Project Description : ROLLING MEADOWS  
PUBLIC SCHOOL  
RENOVATIONS

**RE: RESPONSE LETTER TO:**  
**1522 Mountain Grove Ave, Burlington, Ontario**  
**Building Permit Application Number 21-009792**  
**Building Permit Application Review Letter # 1**

This letter is in response to your mechanical review comments dated August 6, 2021:

SEE ATTACHED RESPONSE LETTER  
DATED AUGUST 11, 2021 FOR PIPING  
AND FITTING MATERIALS

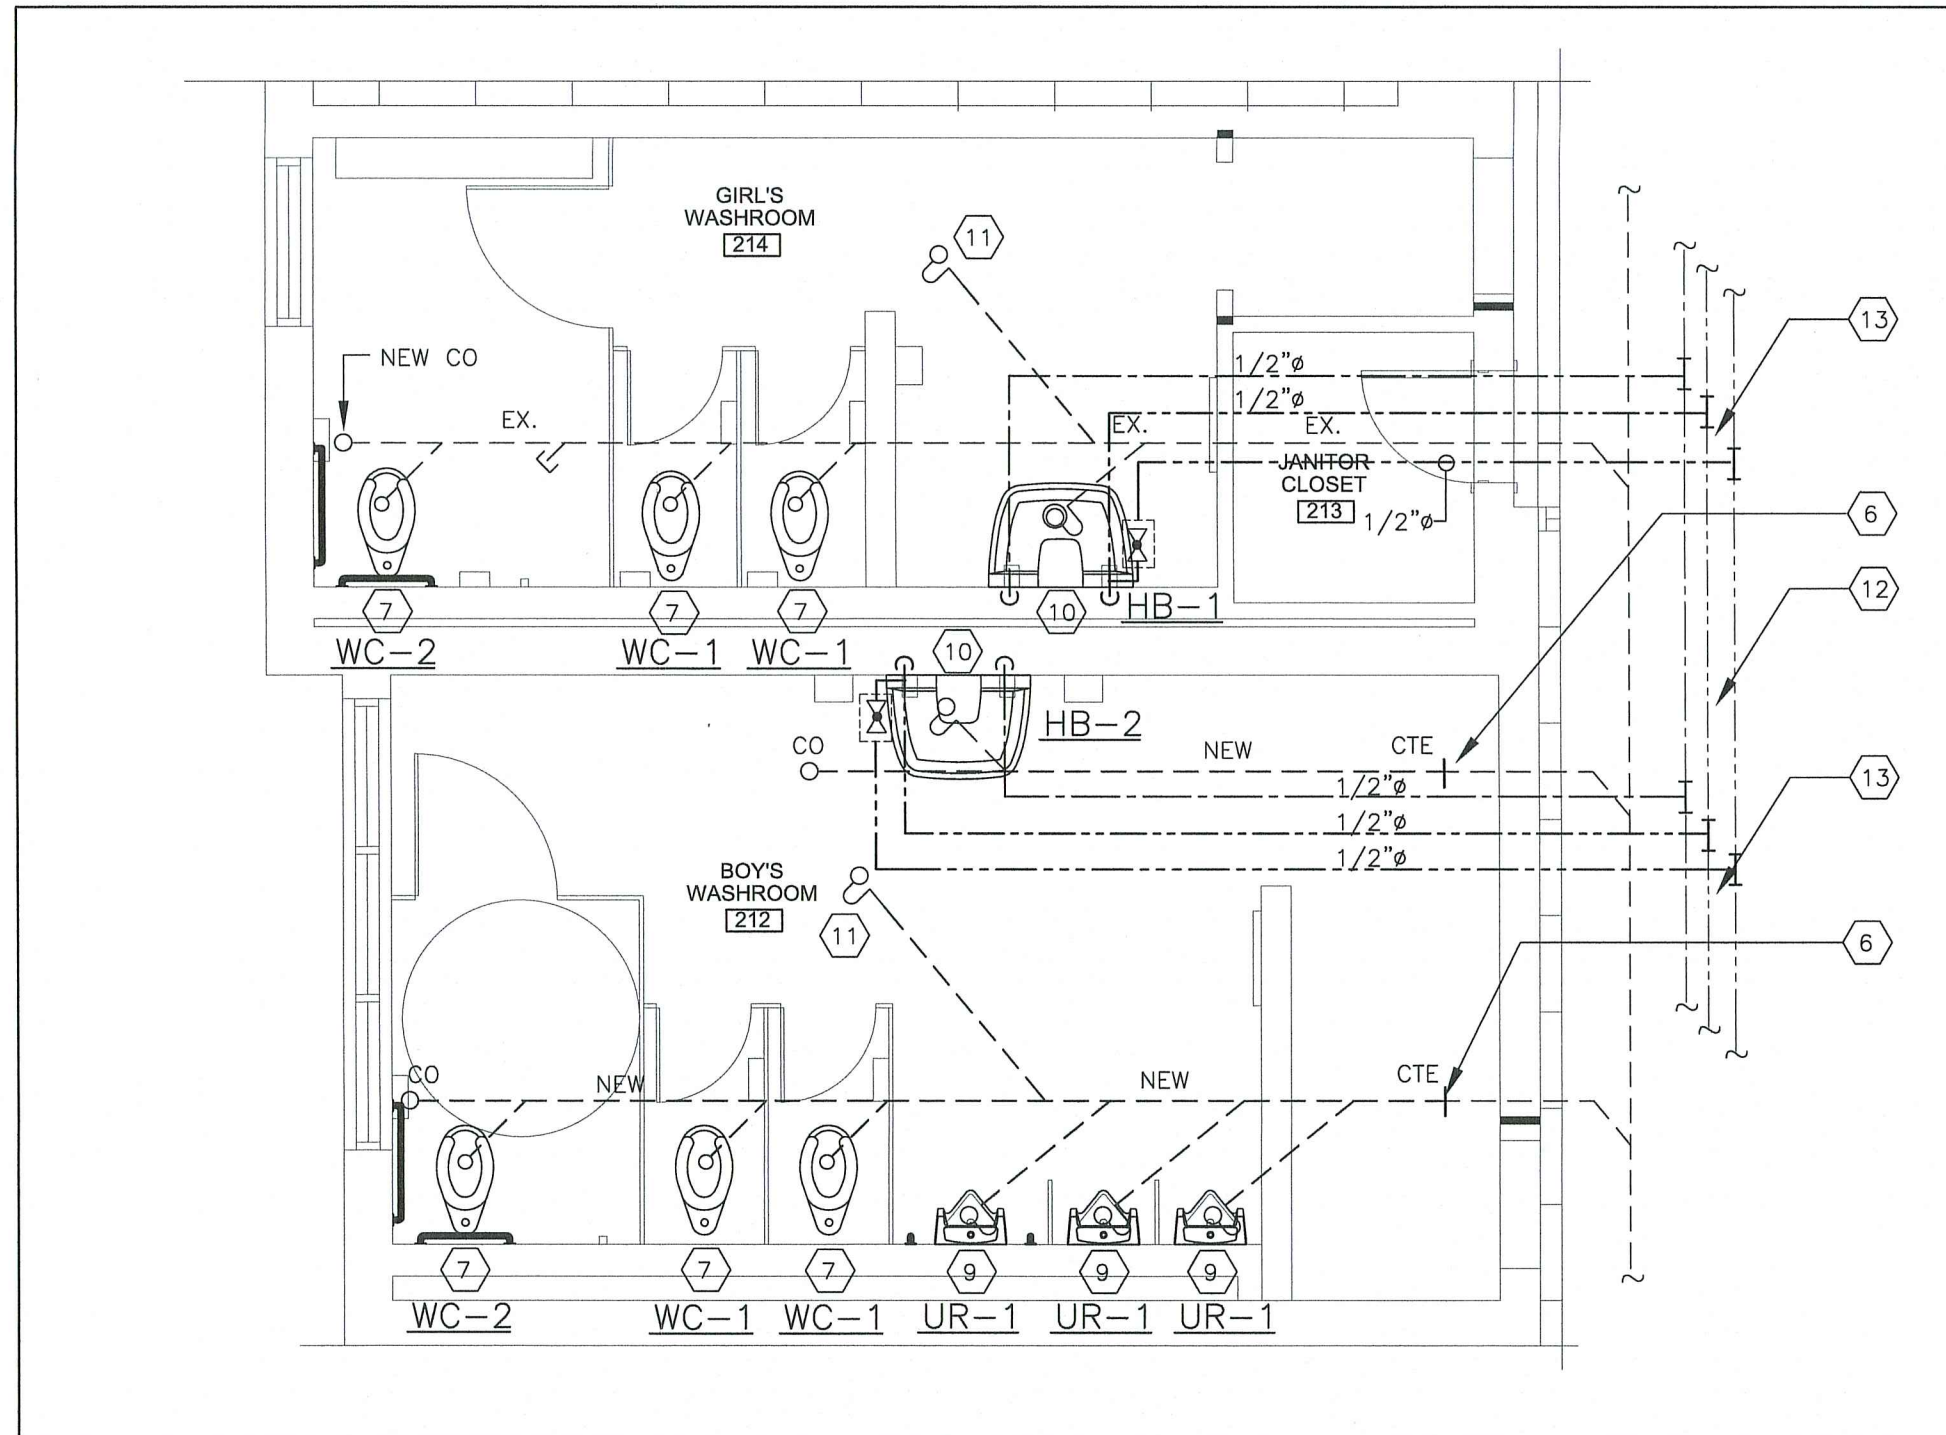
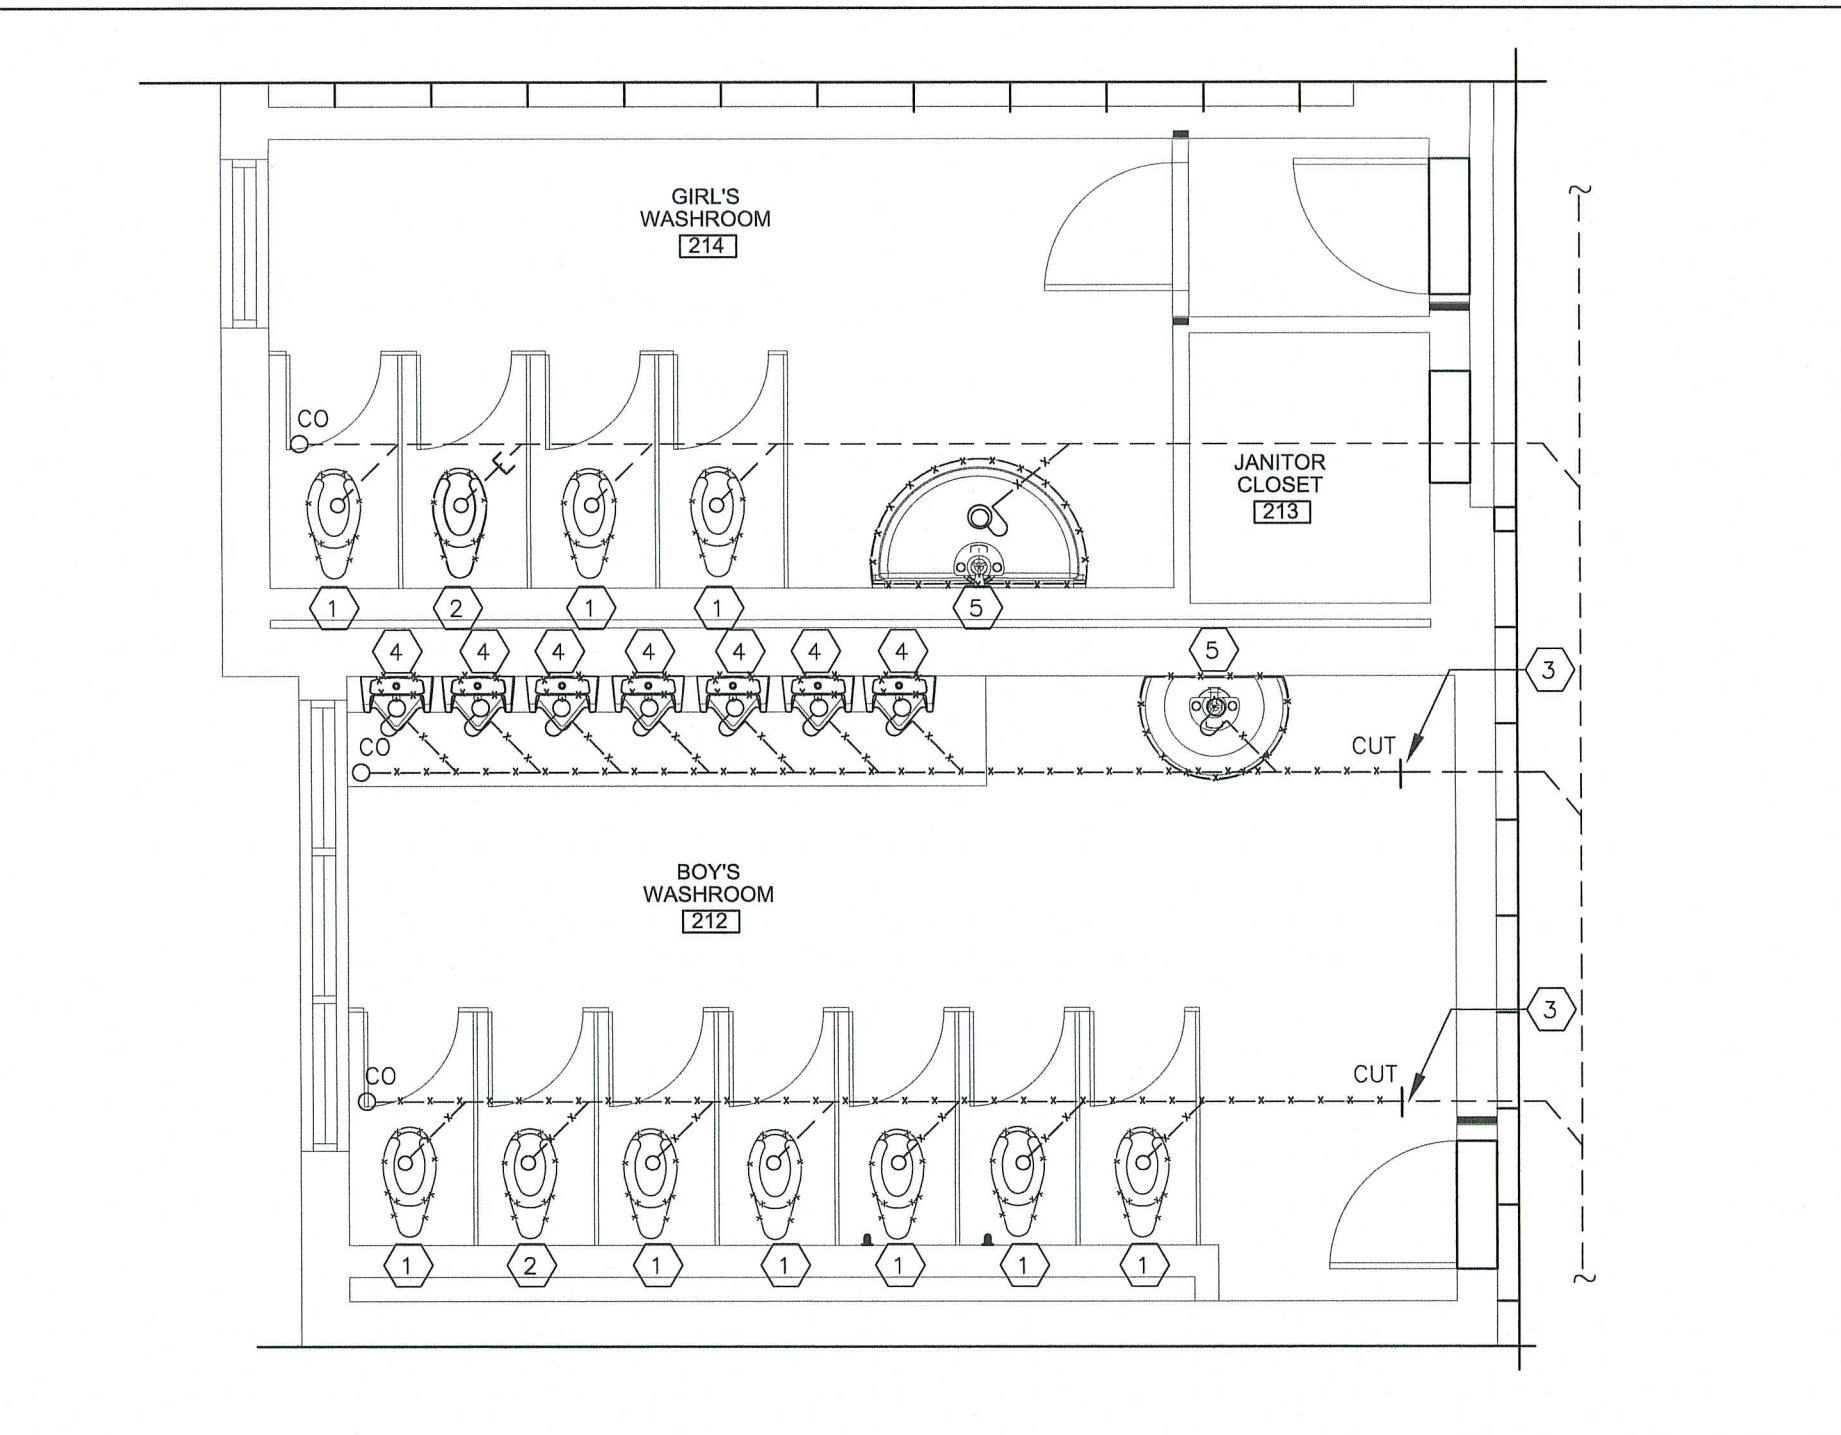
- 5) Provide drainage, venting and water distribution piping/fitting materials.

Hot and cold-water piping – Type 'L' copper  
Above ground / exposed drains 2" dia or less – DVW Copper  
Above ground / exposed drains 3" dia or larger – Cast Iron  
Exposed piping to fixtures and brass – Heavy chrome plated
